ATTACHMENT A – TRANSGRID PROJECT ASSESSMENT REPORTS

INDEPENDENT PLANNING REVIEW

Published: **August 2014**

Figure 1: Gunnedah–Narrabri–Moree area transmission network

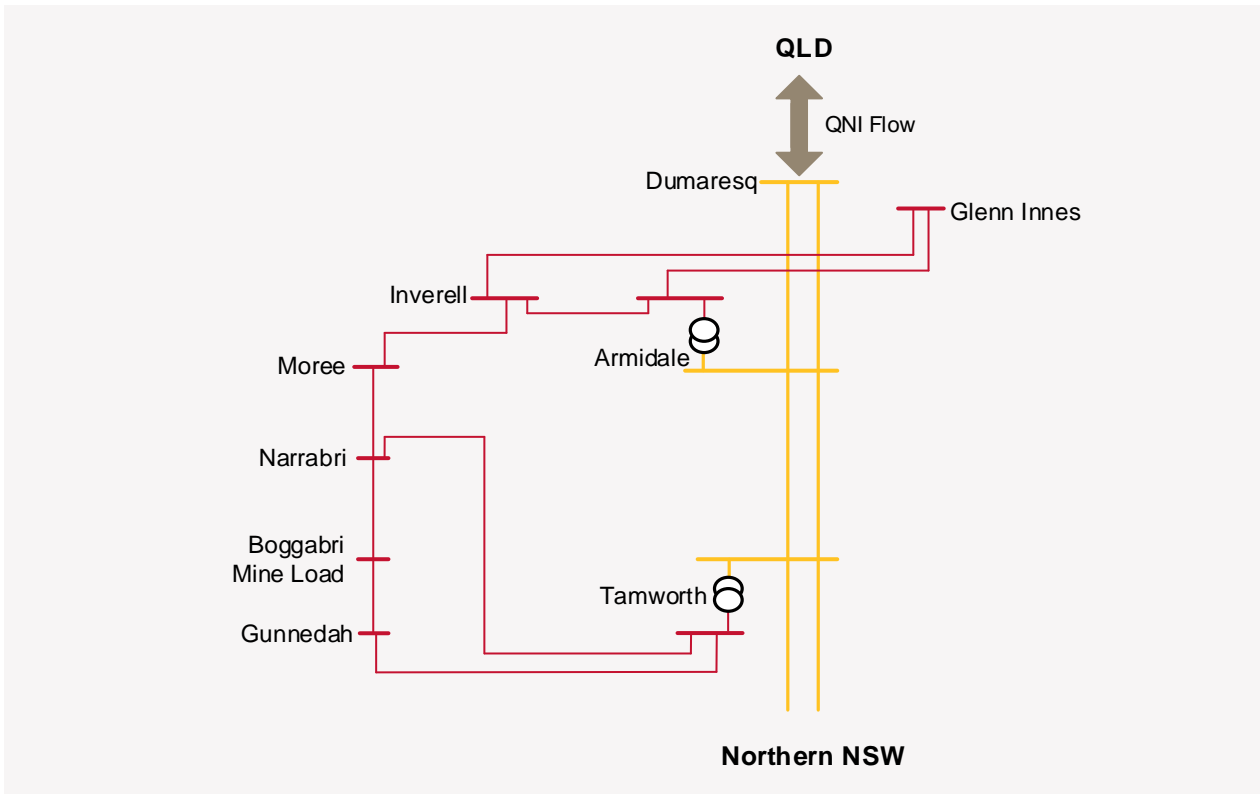
AEMO's analysis indicates that augmenting the network by constructing a new 132kV line from Tamworth to Gunnedah will not be required in the medium term due to the relatively small amount of demand at risk over the 10-year forecast period. AEMO considers that this energy at risk may be contracted and resolved through demand side management or other more economic options.

- TransGrid's proposal to install a phase shifting transformer connecting into 969 line to induce more flow through line 9U2 to supply the Gunnedah area is a credible option.
- Installing reactive power support at key locations, together with Moree solar PV generation dispatch and demand side management may be a credible option.

Figure 7: Inner Sydney area transmission network

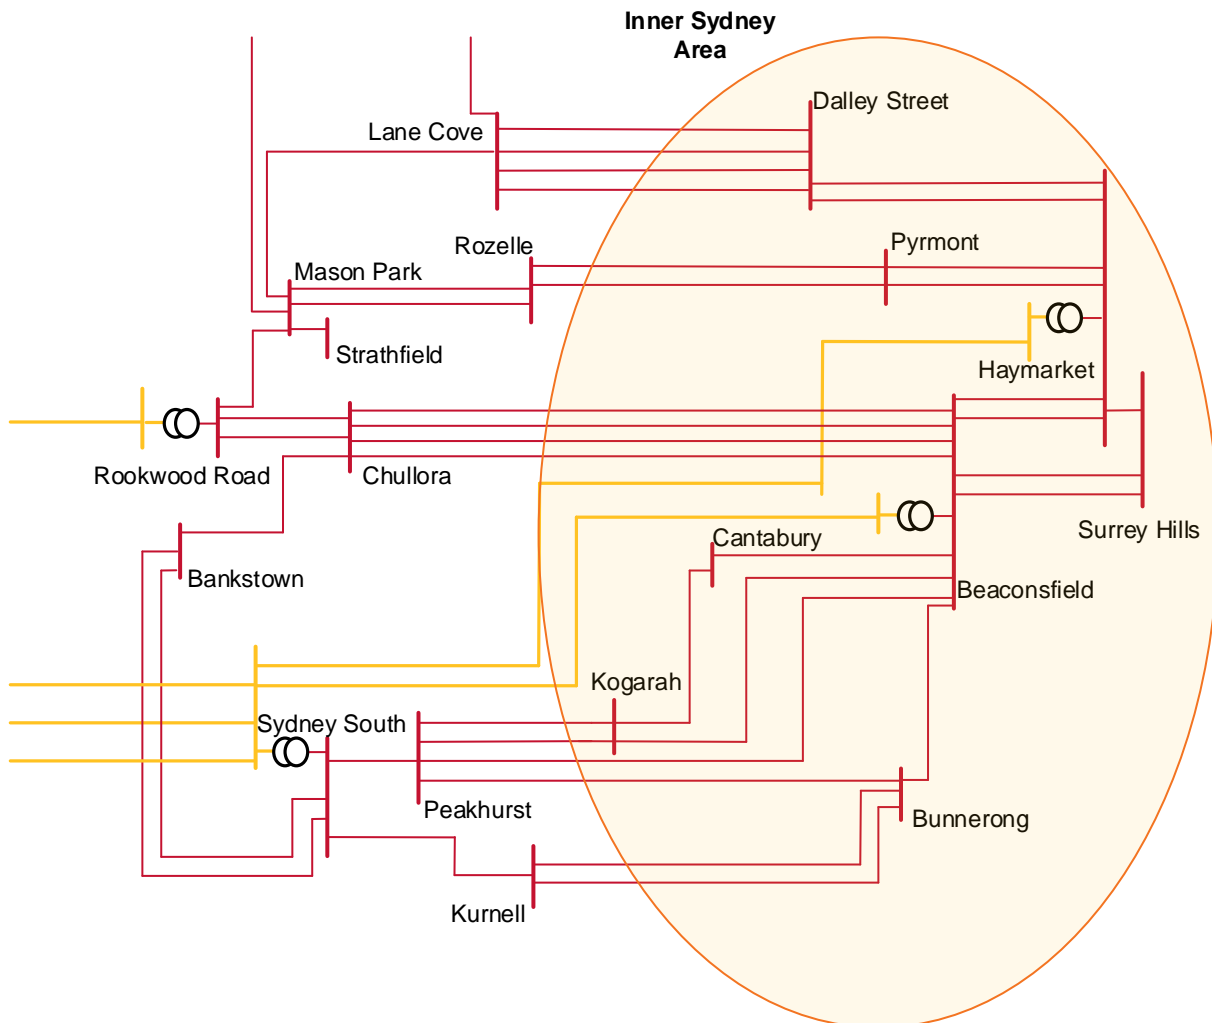
AEMO considers the augmentation of the supply to the inner Sydney area should be contingent on assessment of network security based on revised demand forecasts, and updated maximum supportable demand calculations, showing a need for augmentation within the next four years. This is given:

- Uncertainty about factors determining maximum supportable demand for the inner Sydney area, including: the condition of the de-rated cables, extent of 132 kV cable retirements and the availability of demand management.
- Relatively low forecast demand growth means the required timing of future network augmentation in the area is very sensitive to changes in maximum supportable demand.

Figure 14: Newcastle substation connection configuration

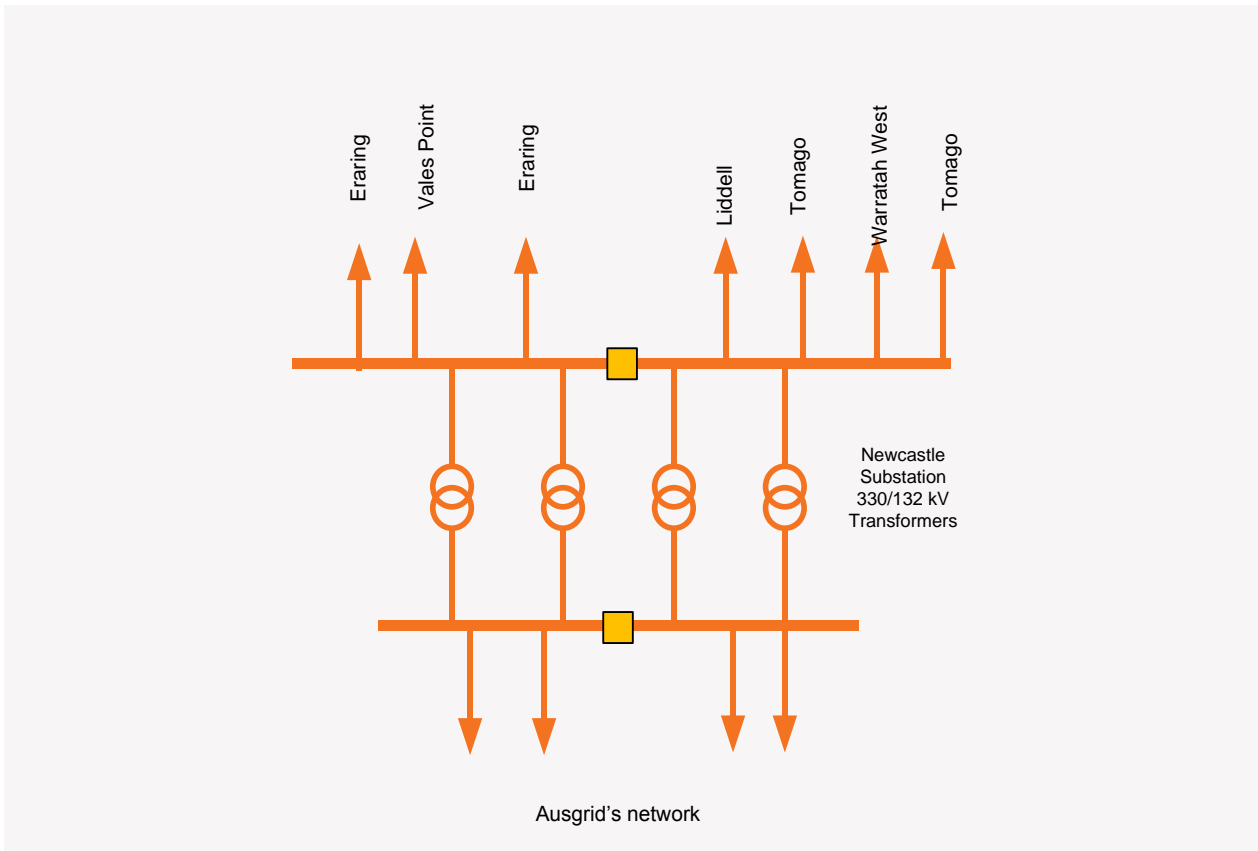
- the single phase transformer set/bank (T3) is expected to be replaced with a 3 phase 375 MVA by the end of 2014.
- TransGrid propose to:
 - Replace the single phase transformer set/bank (T3) with a 3 phase 375 MVA by the end of 2014.

- Retire the single phase transformer set/bank (T4) - originally planned to be replaced by 2016 - due to lower demand in the area following the closure of the Kurri Kurri aluminium smelter.

Figure 16: Tamworth substation connection configuration

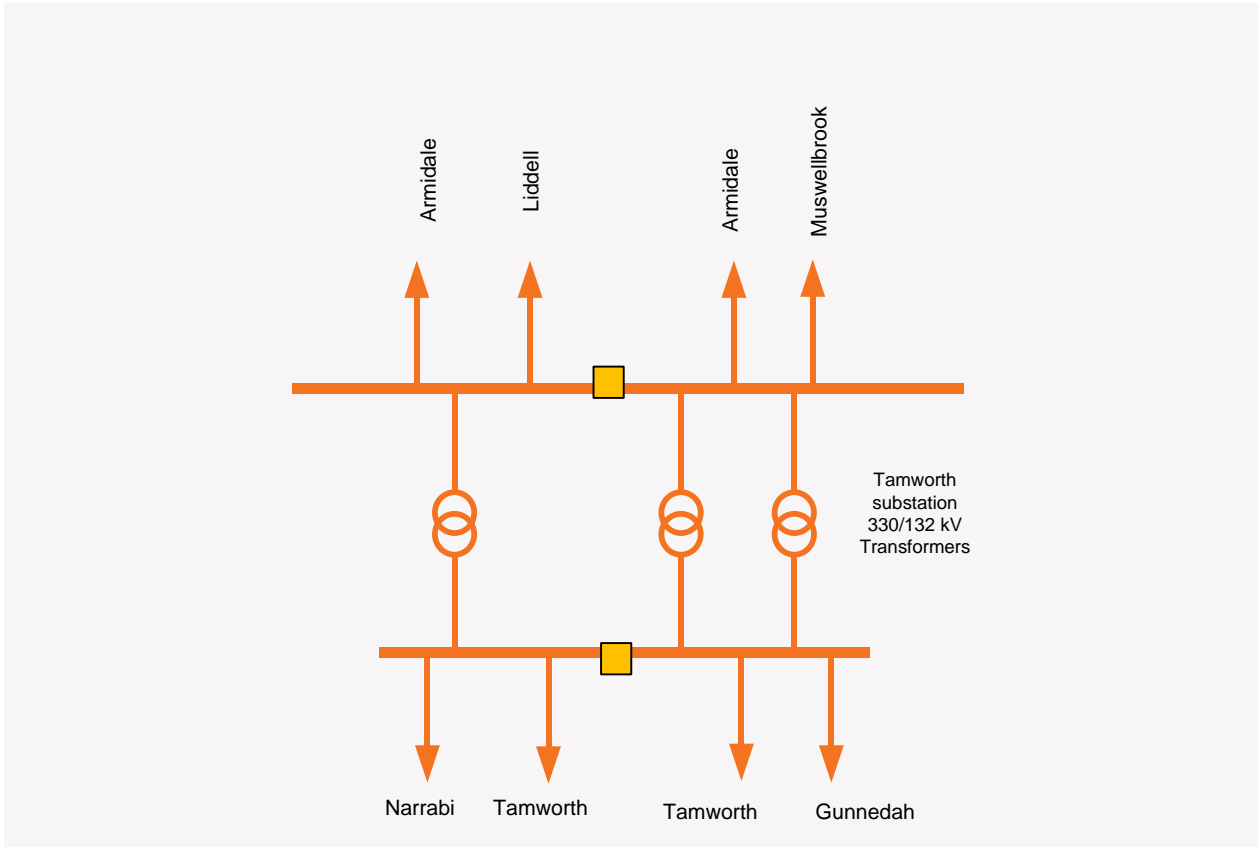
- AEMO considers that:
 - The replacement of transformer T2 is justified to meet network capacity requirements.
 - There is potential to replace the existing three 150 MVA transformers with two higher capacity transformers, depending on the replacement need for transformers T1 and T3.
